FED. ROAD DIST. NO.	STATE	PROJ. NO.	FISCAL YEAR	SHEET NO.	TOTAL SHEETS
HAWAII	HAW.	CMAQ-0300(83)	2002	29	42

DETAILS

PEDESTRIAN FACILITIES and ADA COMPLIANCE
Various Locations On Oahu
Federal Aid Project No. CMAQ-0300(83)

CURB RAMP, TYPE "C" DETAIL (3C)
Not to Scale

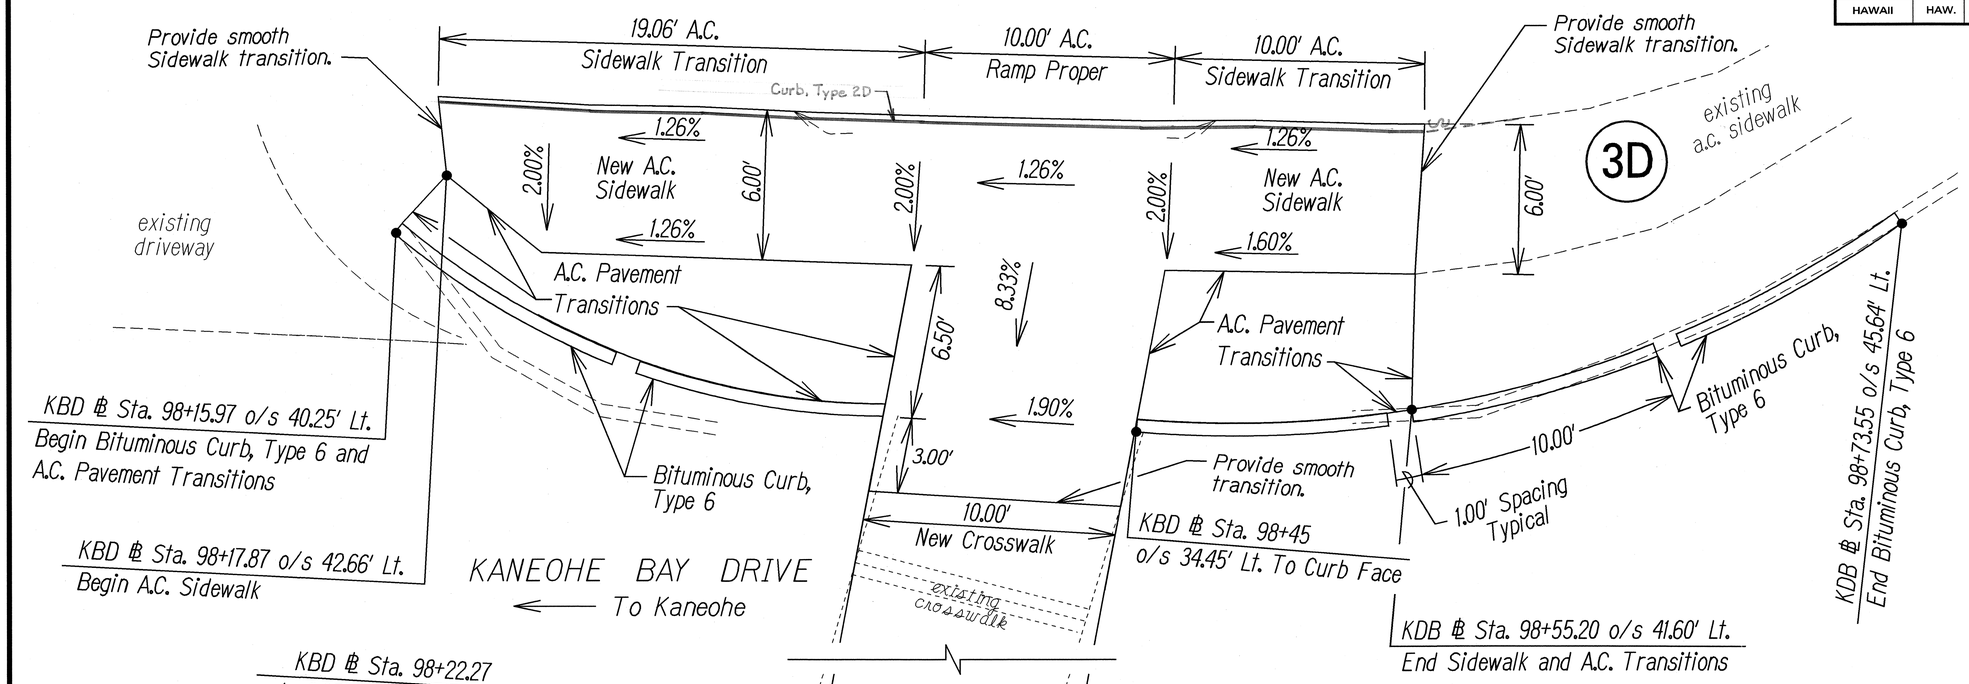
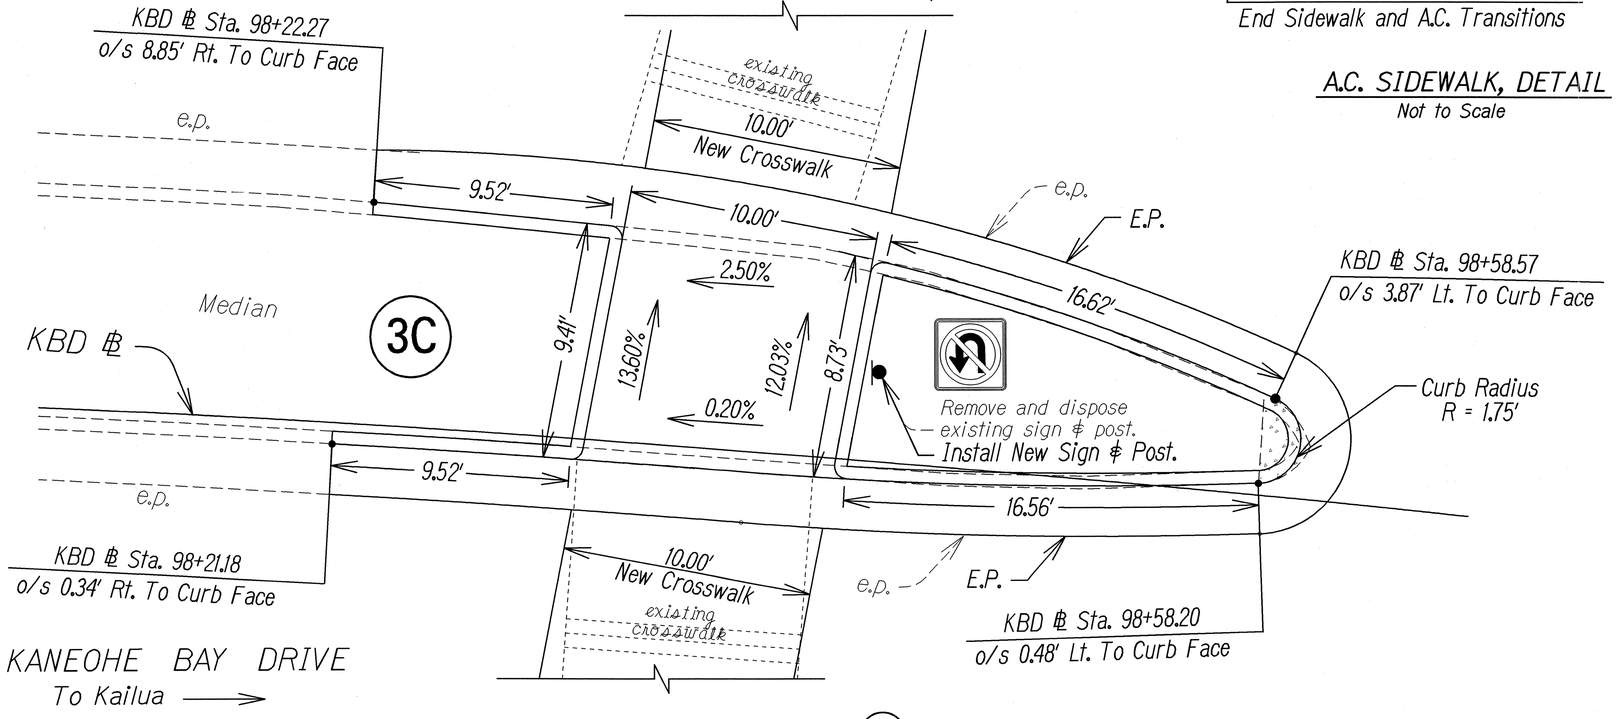
DATE	REVISION
1/8/02	Revised and added sign call-out for Detail 3C. Revised and added dimensions, call-outs and title for Detail 3D.

ADD.35

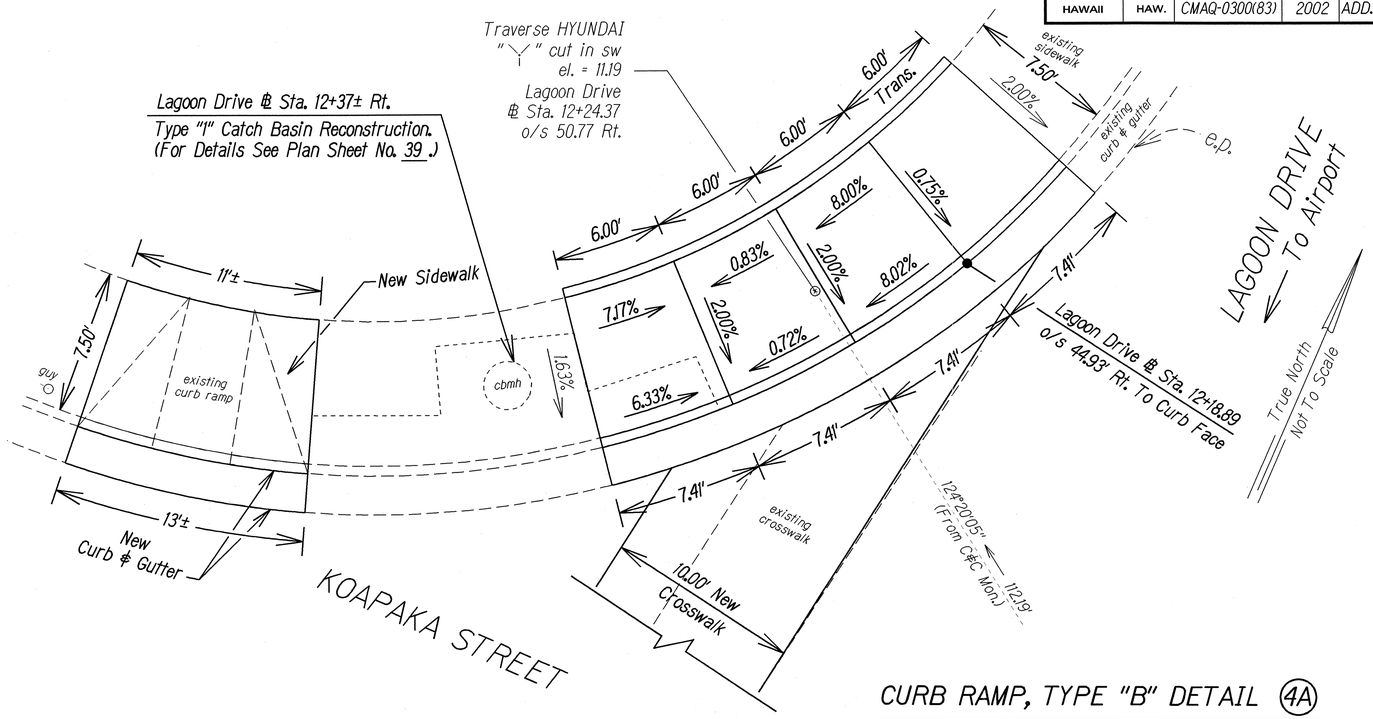
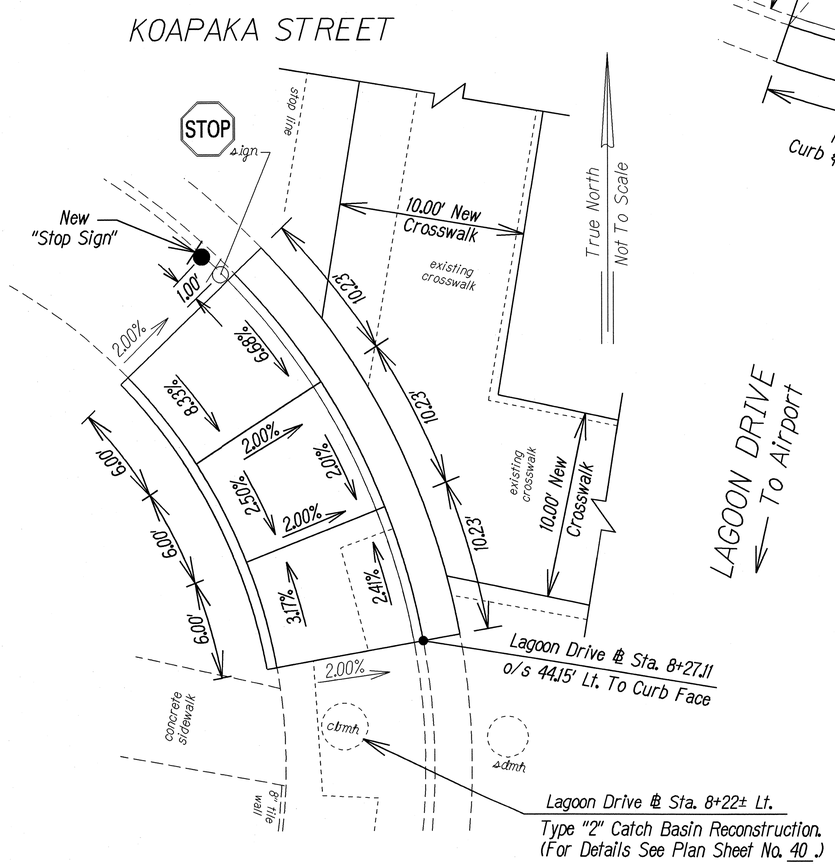
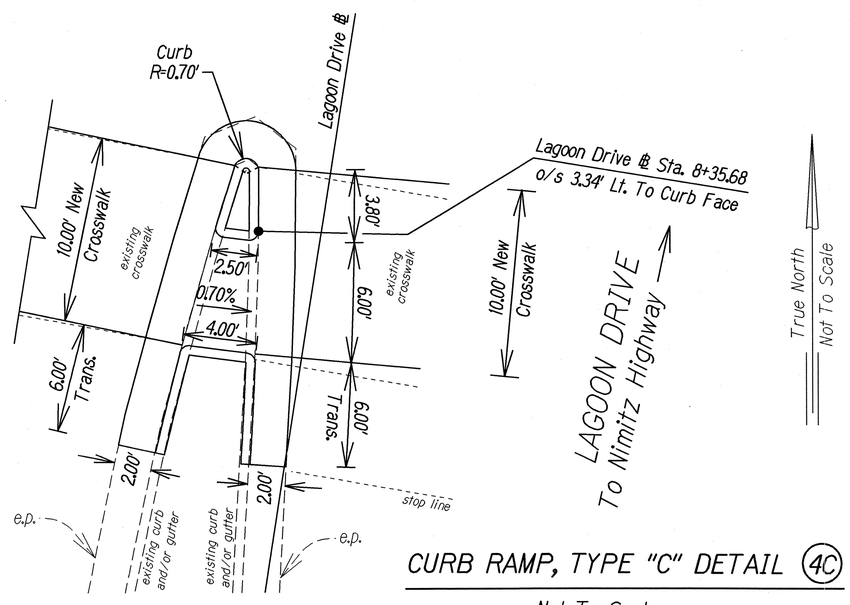
DATE	REVISION
1/11/02	Revised location of New Standard Curb from within the sidewalk limit to the outside of the sidewalk limit.

ADD.36

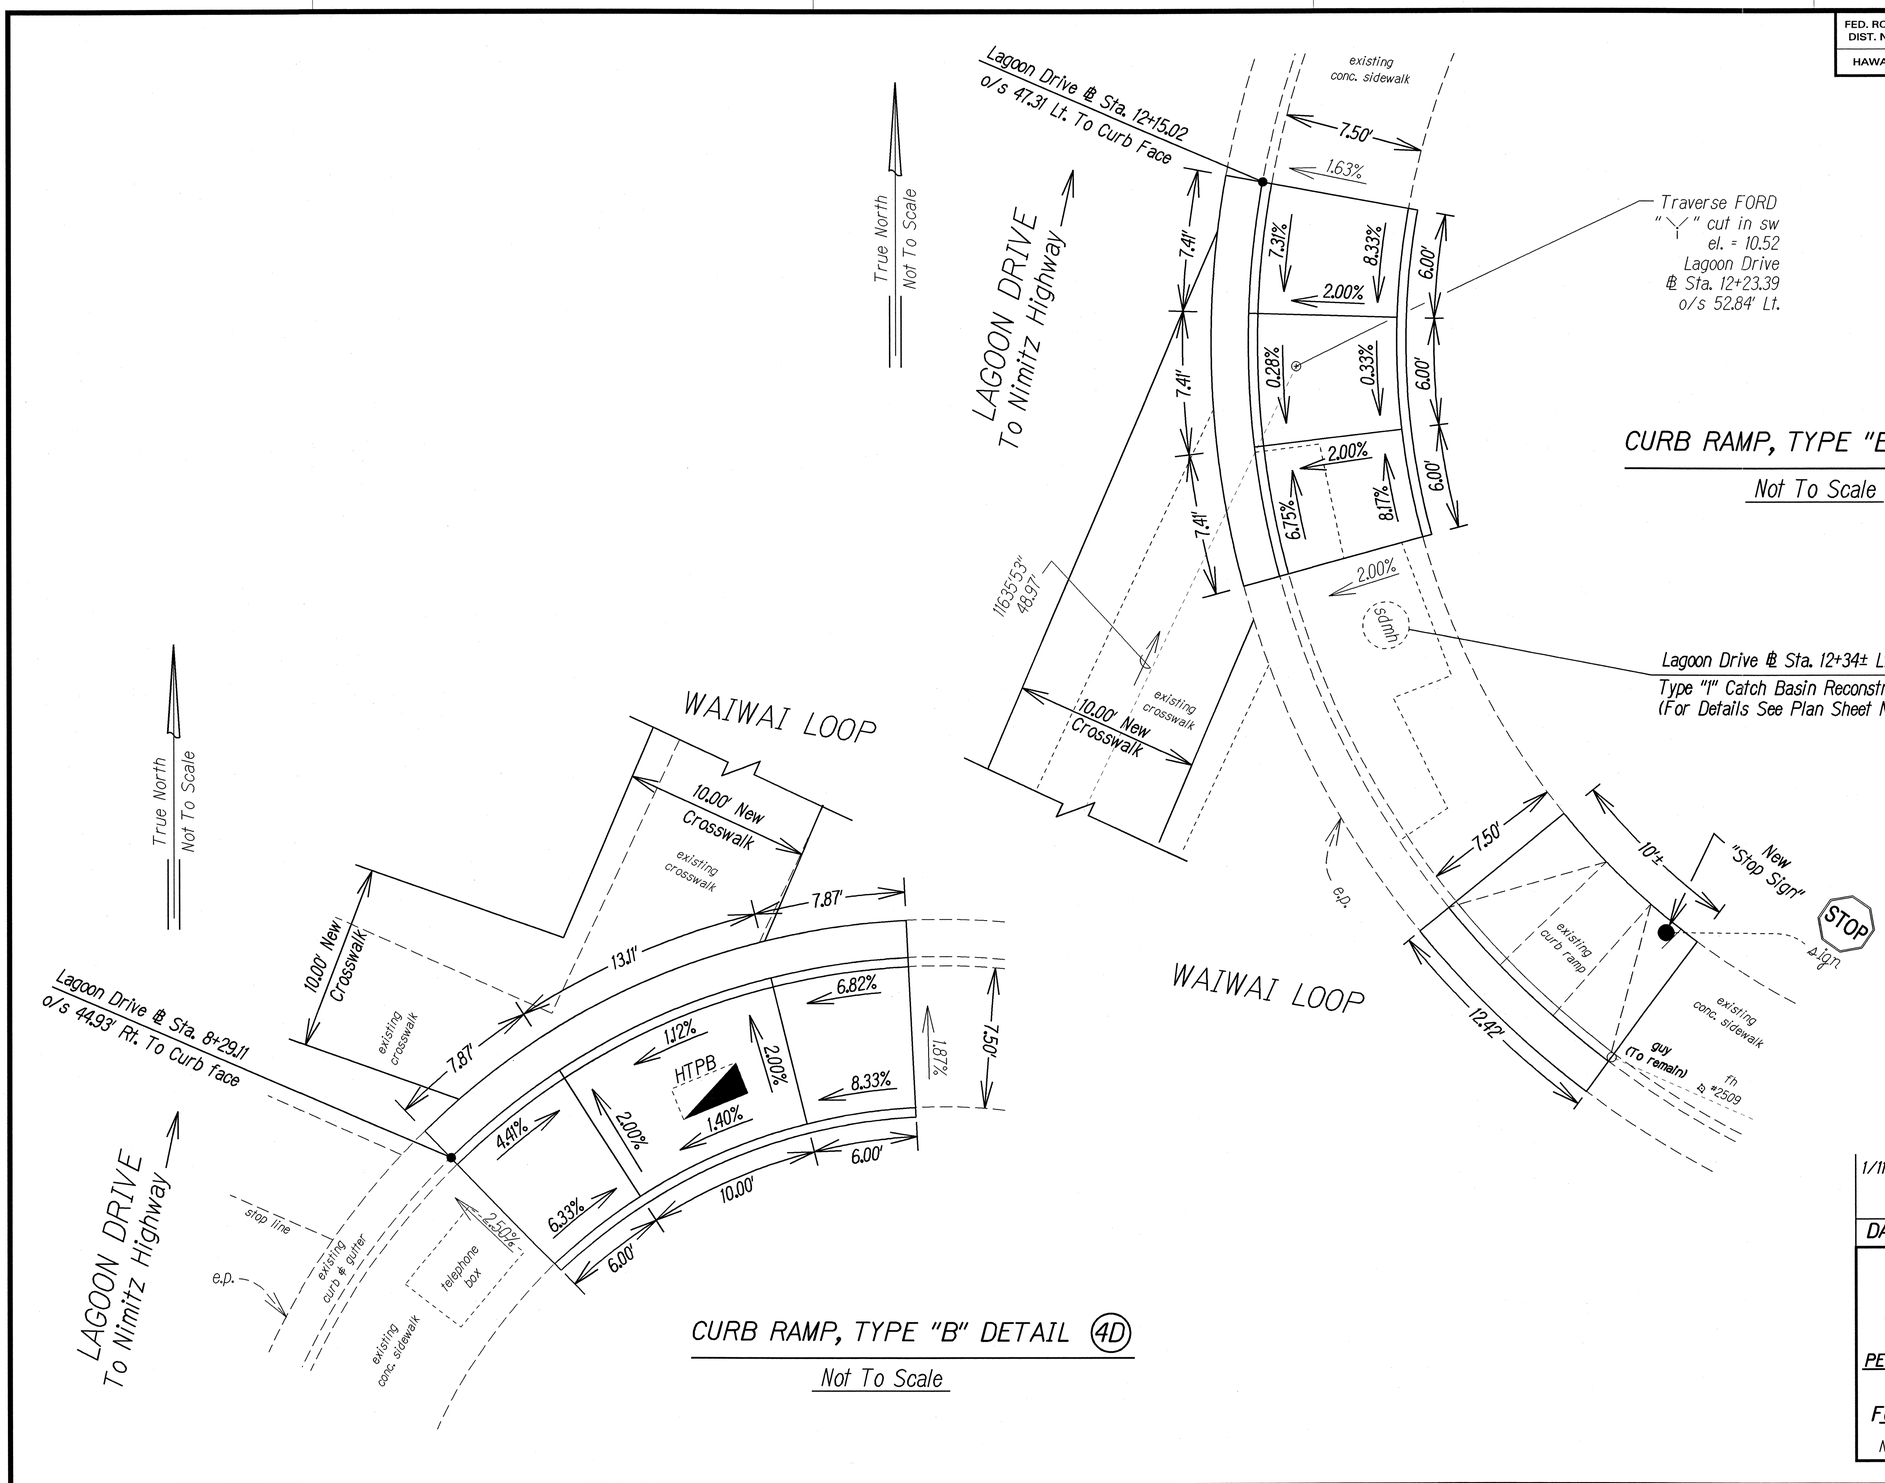
DATE	REVISION
1/11/02	Revised location of New Standard Curb from within the sidewalk limit to the outside of the sidewalk limit.

ADD.37

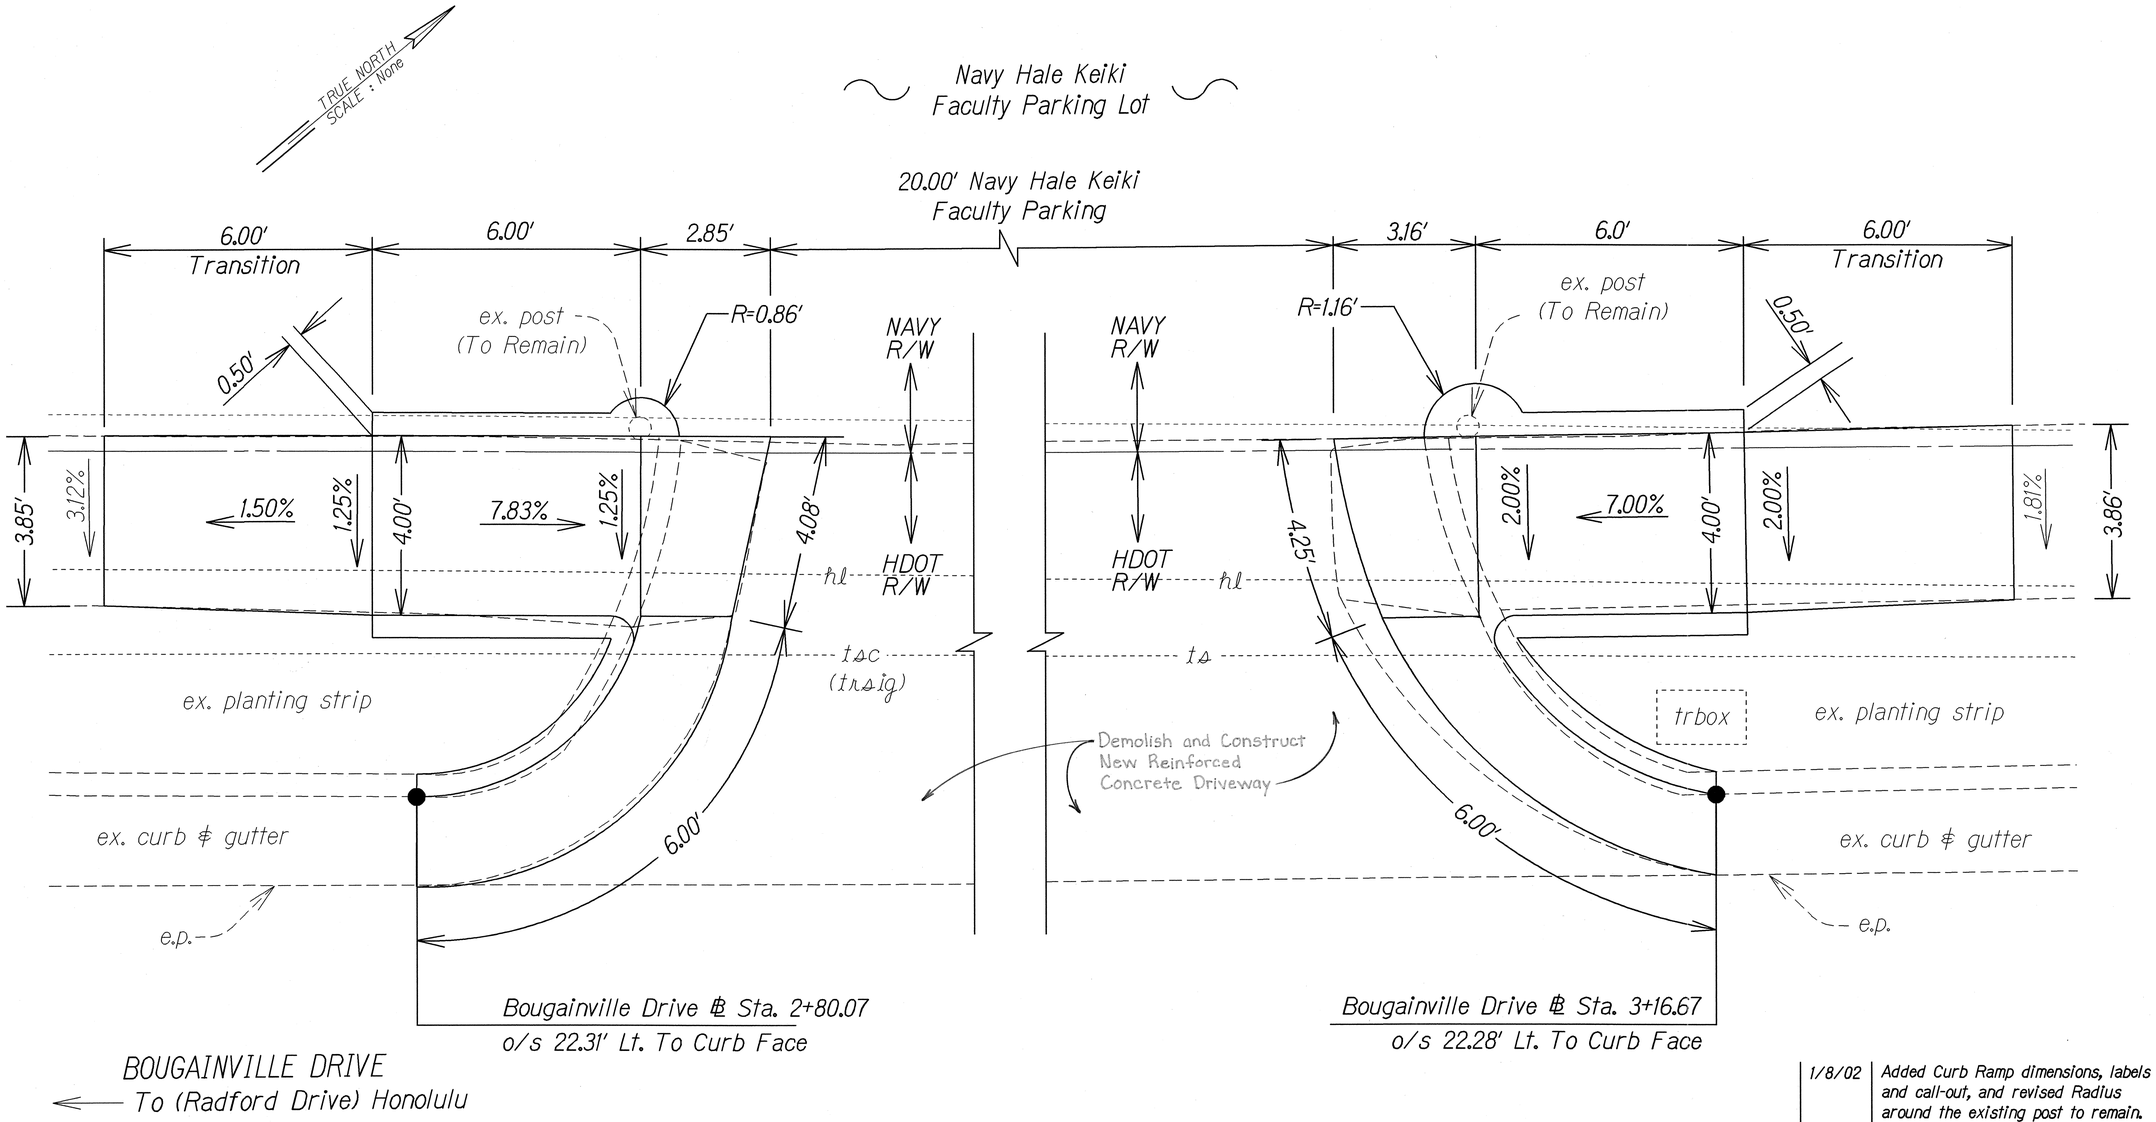
DATE	REVISION
1/8/02	Added Curb Ramp dimensions, labels and call-out, and revised Radius around the existing post to remain.
